# TECHNICAL BULLETIN

**MODEL/DERIVATIVE:**  
Defender

**Bulletin N°:** 0021  
**CDS. ref:** L8678bu  
**Issue:** 1  
**Date:** 12.12.01

**PROBLEM:**  
FRONT RADIUS ARM NOISE / CREAK

**Illustration shows radius arm bracket without welded washers**

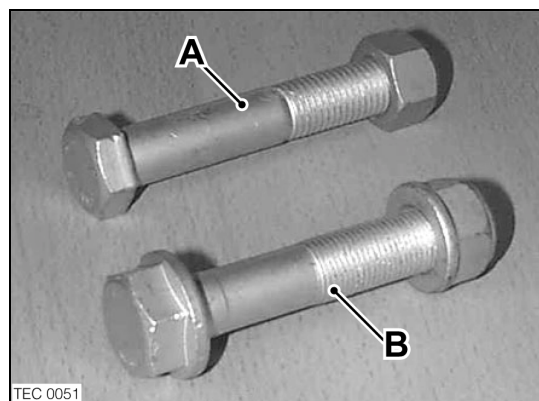
Where a complaint of the above is confirmed, inspect the front radius arm to axle case brackets. If the brackets do not incorporate a welded washer and the nuts and bolts are to the old specification, (see illustration 1) and ('A' in illustration 2), the nuts and bolts must be replaced with the new specification flange headed nuts and bolts, ('B' in illustration 2).

1. Raise vehicle on lift.
2. Remove nut from radius arm bolt to axle case bracket and remove bolt.
3. Fit new radius arm bolt and nut to axle case bracket, torque to 210 Nm.  
Caution: Ensure torque does not exceed 230 Nm.
4. Repeat steps 2 – 3 for the remaining fixings. Replace fixings individually.

**Illustration shows radius arm bracket with welded washers**

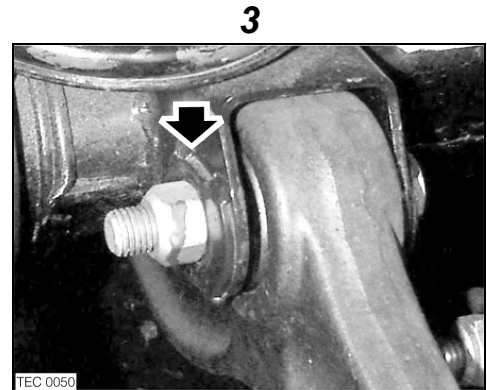
**Caution: Vehicles with the welded washer on radius arm axle case bracket, (arrowed in illustration 3), torque radius arm fixing bolt and nut to 176 Nm, ensure torque does not exceed 185 Nm.**
